RE: ***Petition No. 1352*** – Nutmeg Solar, LLC, petition for a declaratory ruling, pursuant to Connecticut General Statutes §4-176 and §16-50k, for the proposed construction, maintenance and operation of a 19.6-megawatt AC solar photovoltaic electric generating facility on approximately 162 acres comprised of 9 separate parcels located generally south of Bailey Road and east of Route 191 (Broad Brook Road), and associated electrical interconnection to Eversource Energy's Scitico Substation at 20 Bailey Road in Enfield, Connecticut.

**STATE OF CONNECTICUT
CONNECTICUT SITING COUNCIL**

Petition No. 1352

Exhibit CSC-14

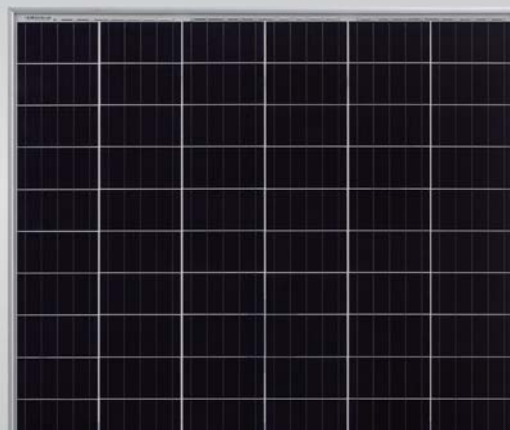
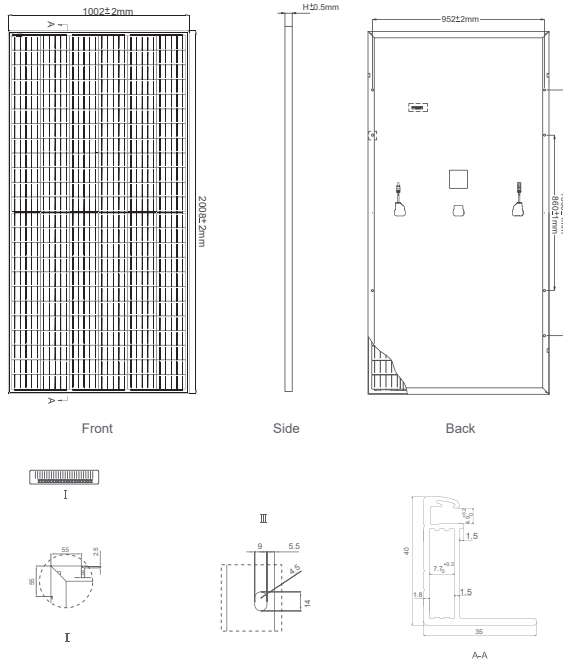
CSC-14 The proposed project is 19.6 megawatts (MW) alternating current (AC). Provide the MW DC of the proposed project. How many solar modules would be installed? According to the specifications sheet of the proposed solar modules, the wattage of each module ranges from about 345 W DC to 355 W DC. What is the estimated watts DC of a proposed solar module?

The proposed Project has a 32.14 MW DC capacity based on current solar module power rating assumptions. The Petitioner has not finalized module selection as the Project will leverage NextEra Energy's integrated supply chain module procurement process to cost-effectively procure modules utilizing the latest photovoltaic technology available.

The Petitioner is contemporaneously filing a revised Exhibit F that reflects best available technology (400 W DC modules). Attached hereto as Exhibit CSC-14 and provided as Revised Exhibit F is a specification sheet for the 400 watt module. Approximately 72,520 modules will be installed. The Petitioner has confirmed that the estimated average annual energy production of 37,000 megawatt-hours is based on the 400 W DC module assumption.
